**Retreat at  
TimberRidge**  
PUD Development Plan  
EL PASO COUNTY, CO

DATE: 06-21-17  
BY: KMM  
DESCRIPTION: Per County Review Comments

**PUD  
DEVELOPMENT  
PLAN**

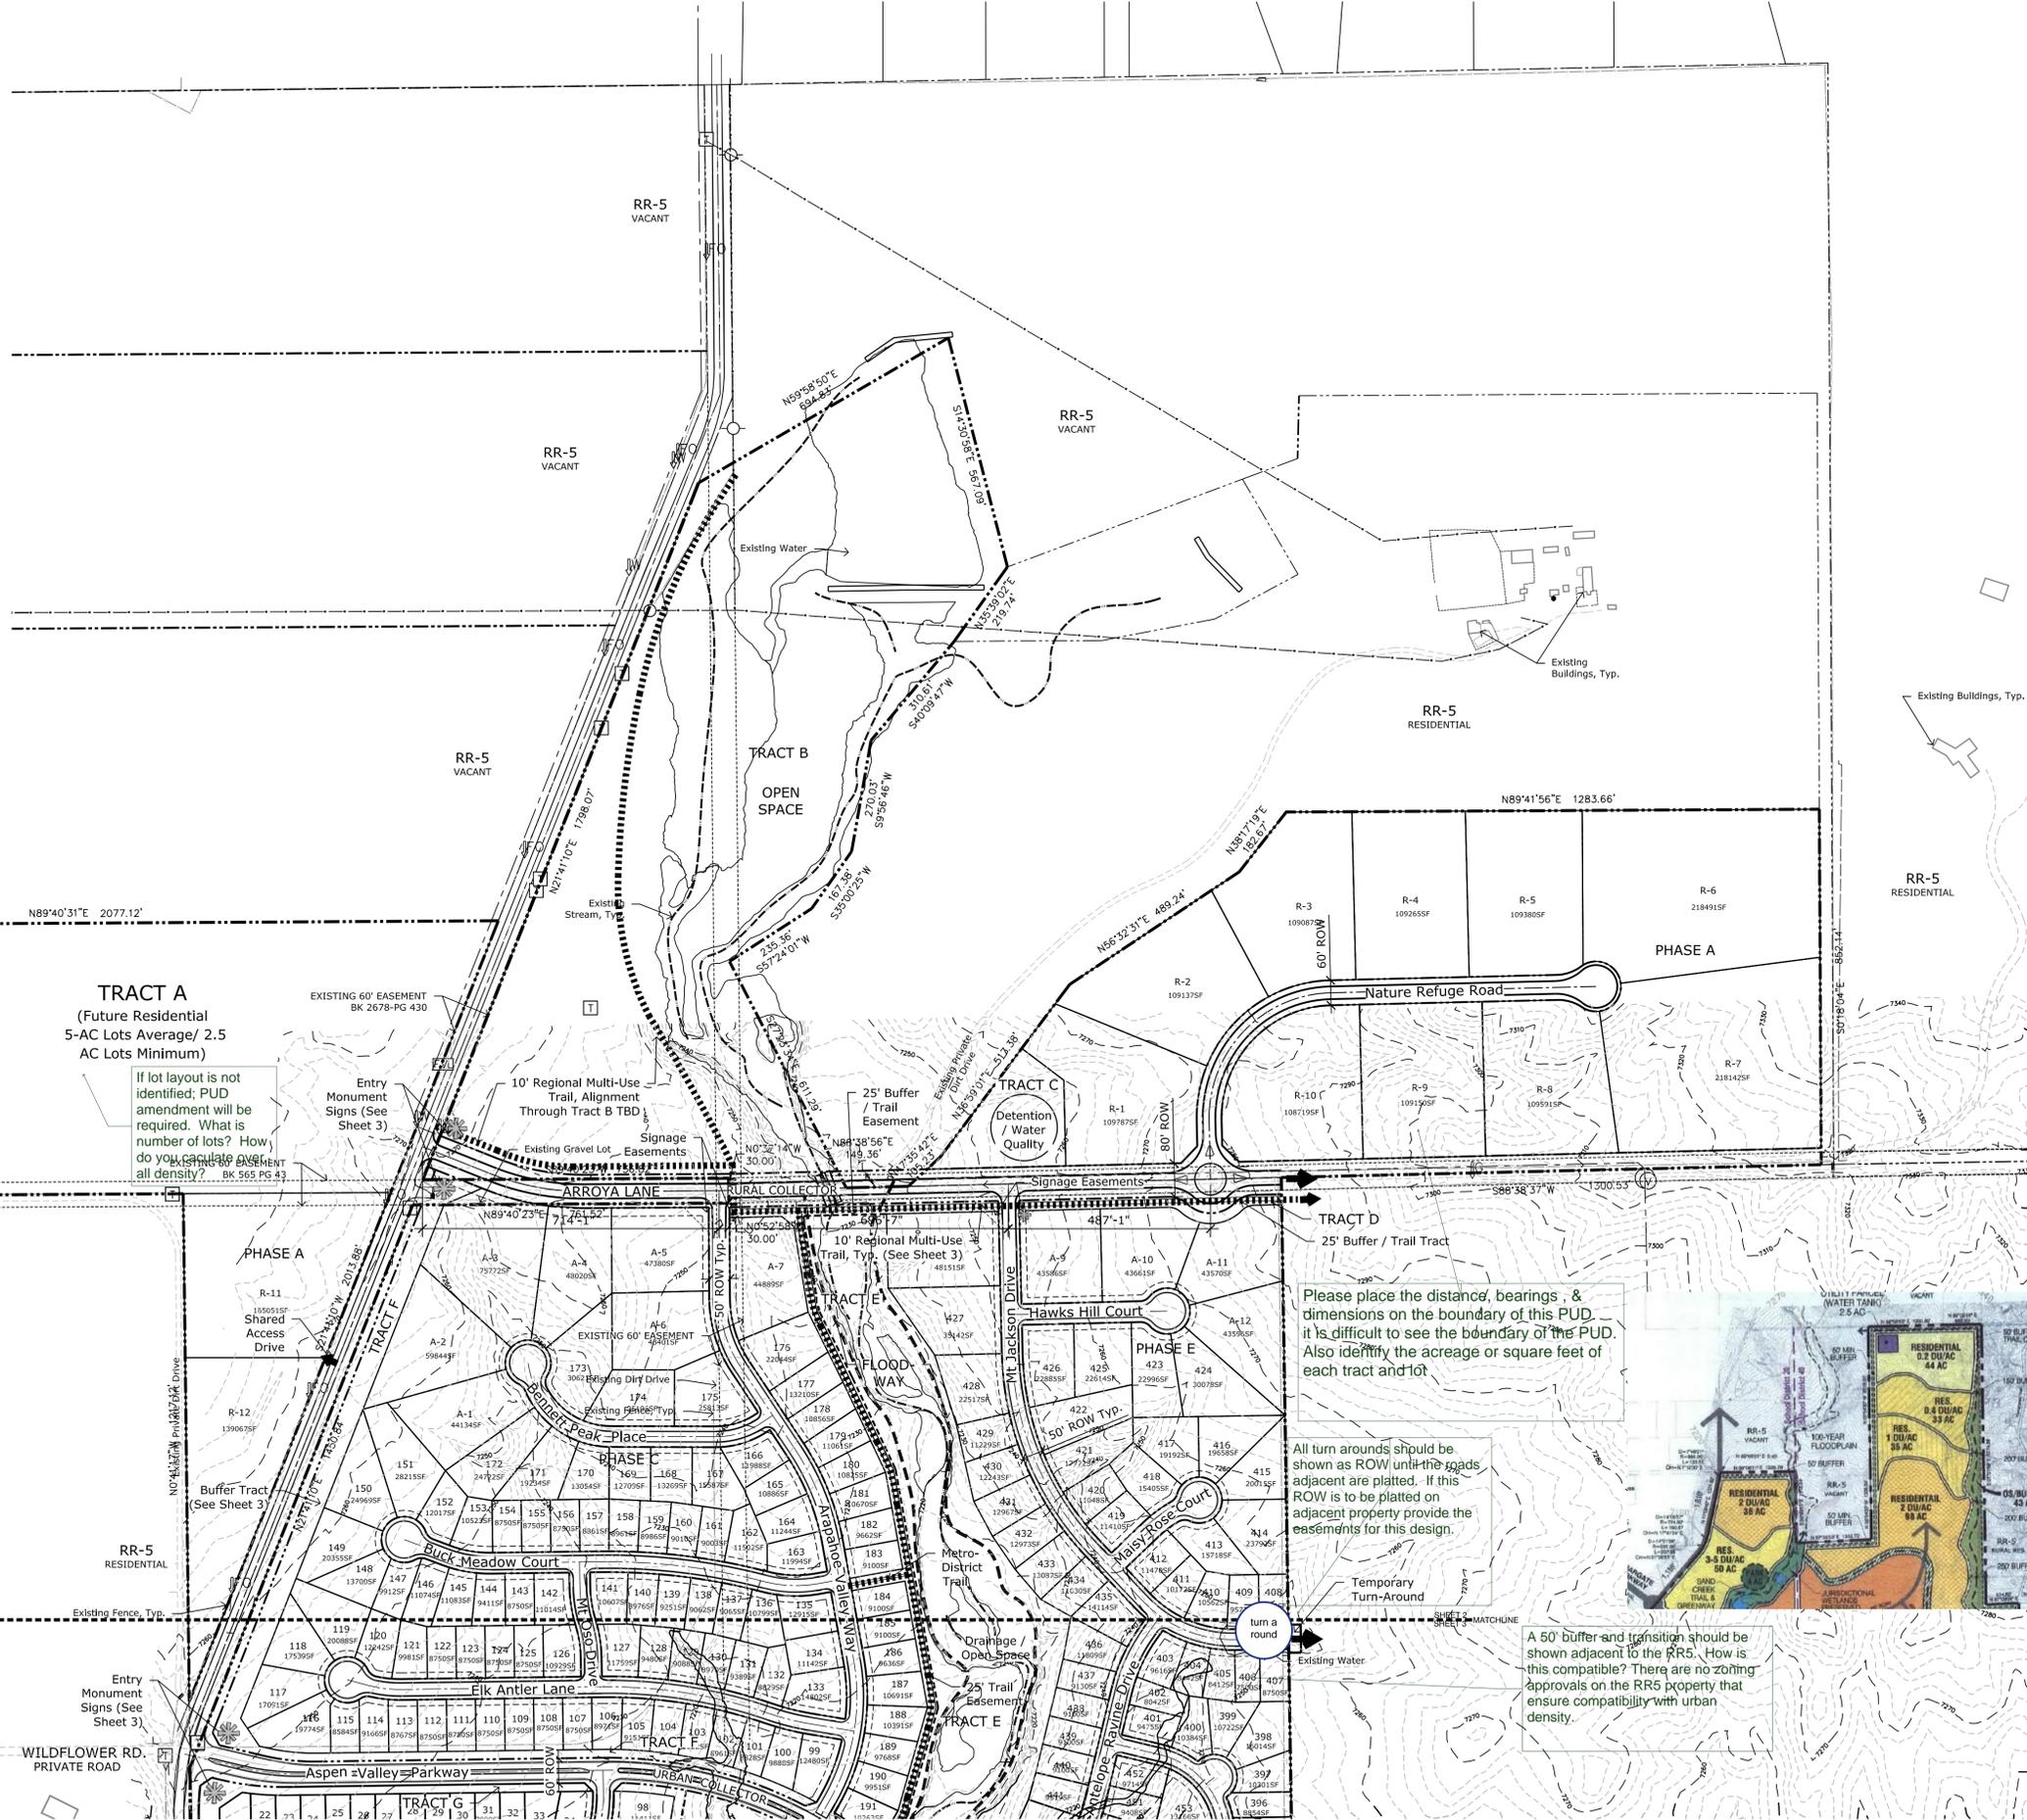
If lot layout is not identified; PUD amendment will be required. What is number of lots? How do you calculate area at all density? BK 565 PG 43

Please place the distance, bearings, & dimensions on the boundary of this PUD. It is difficult to see the boundary of the PUD. Also identify the acreage or square feet of each tract and lot.

All turn arounds should be shown as ROW until the roads adjacent are platted. If this ROW is to be platted on adjacent property provide the easements for this design.

A 50' buffer and transition should be shown adjacent to the RR5. How is this compatible? There are no zoning approvals on the RR5 property that ensure compatibility with urban density.

PHASE MAP

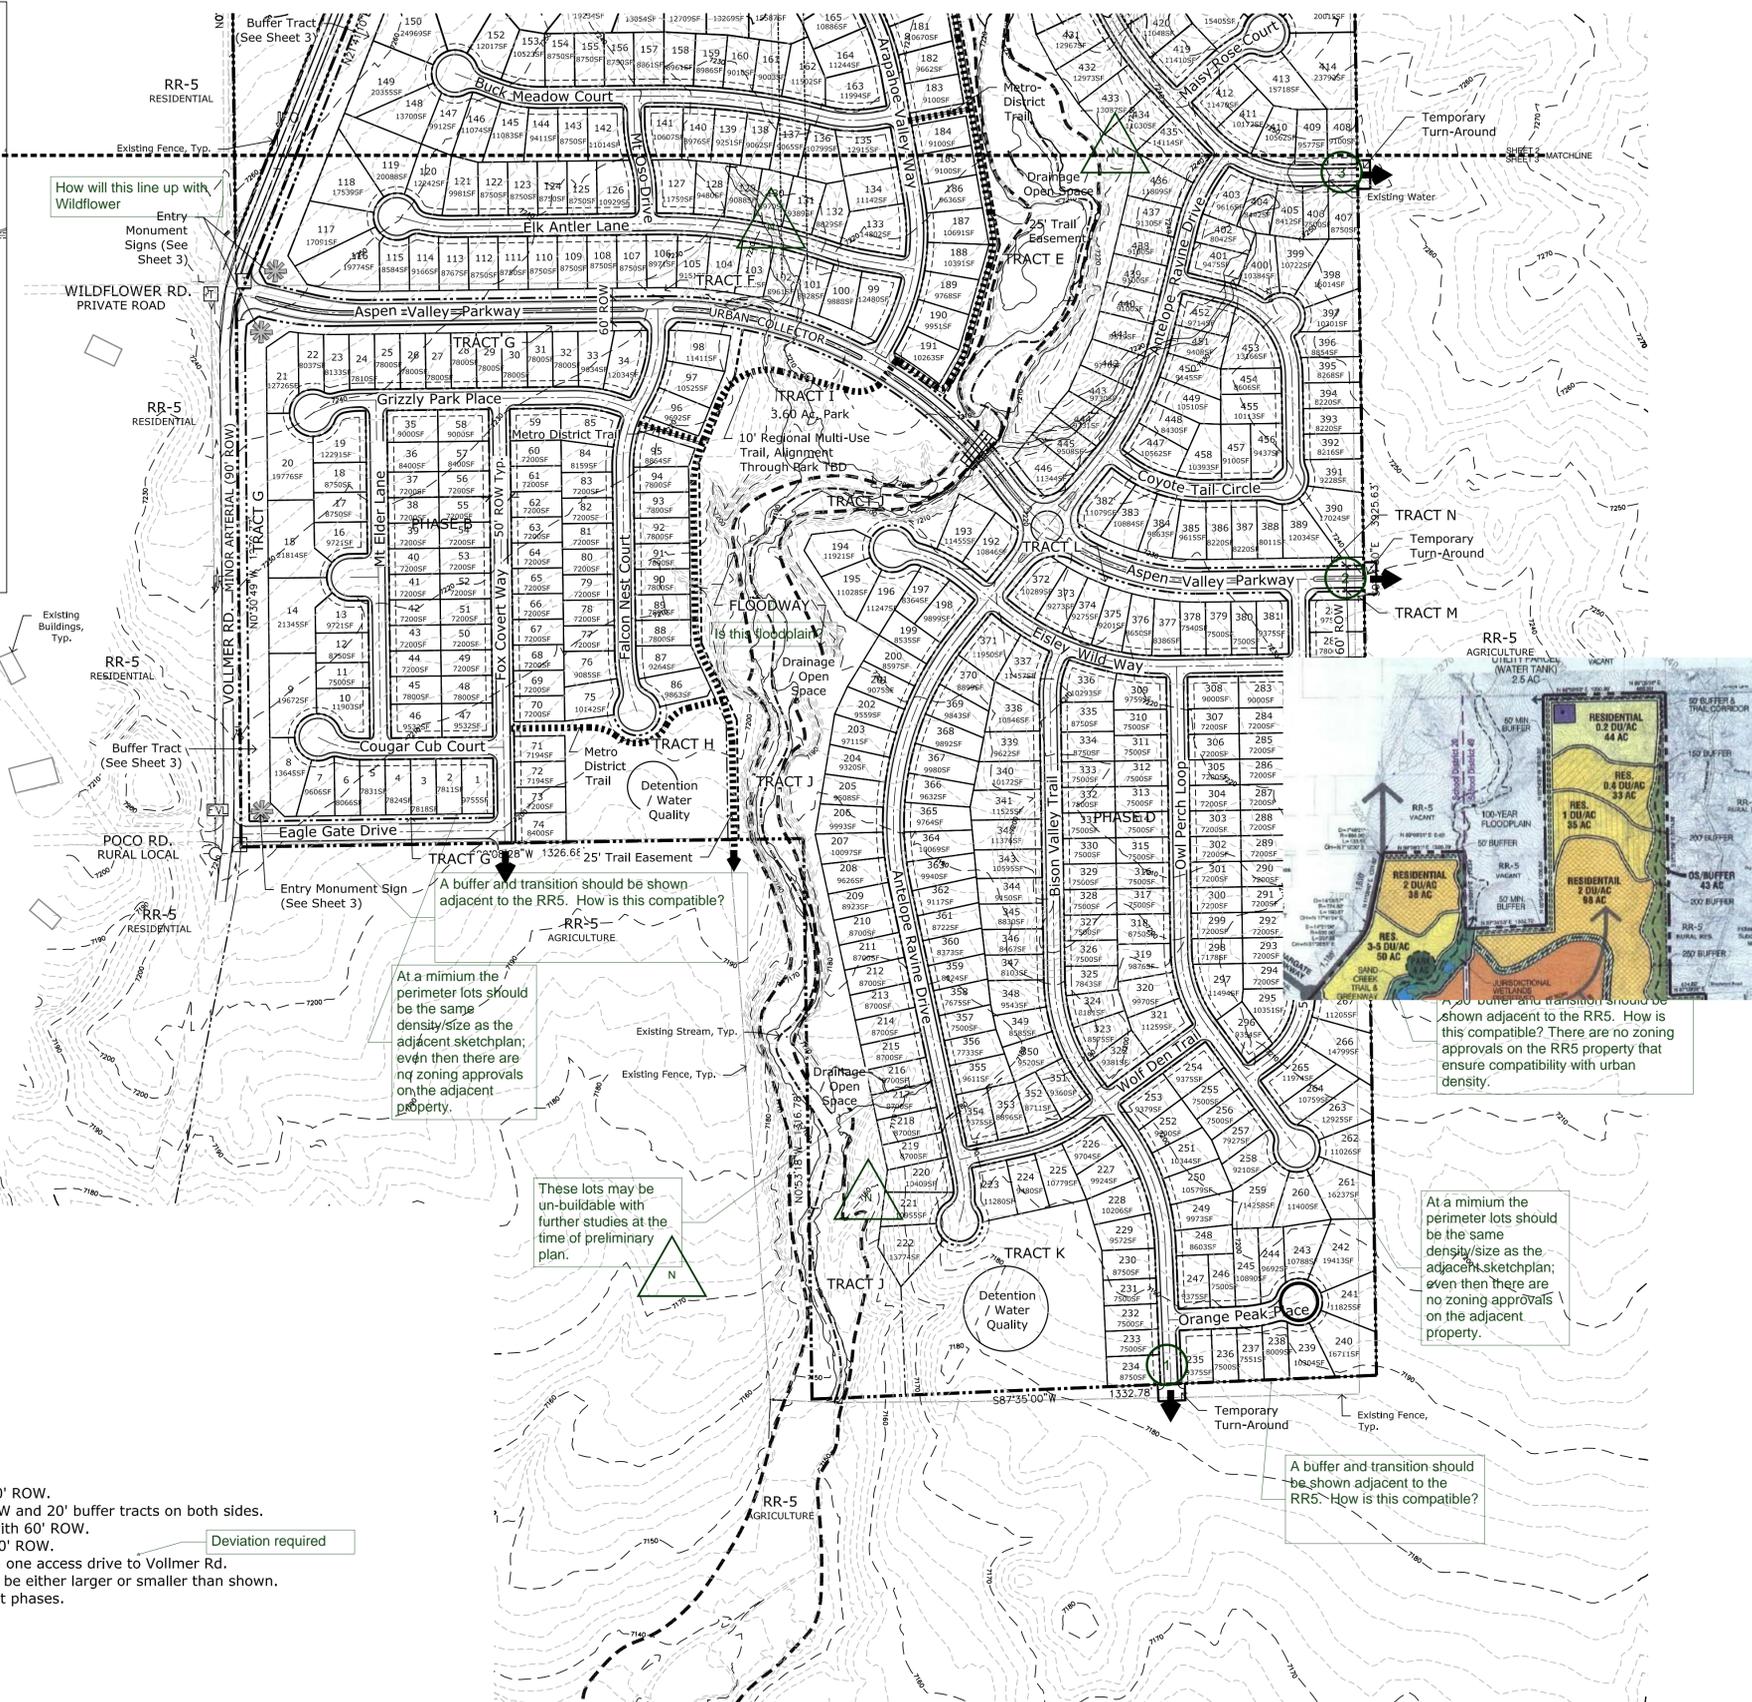
At a minimum the perimeter lots should be the same density/size as the adjacent sketchplan; even then there are no zoning approvals on the adjacent property.

A buffer and transition should be shown adjacent to the RR5. How is this compatible?

How will this line up with Wildflower

Is this floodplain?

Deviation required

These lots may be un-buildable with further studies at the time of preliminary plan.
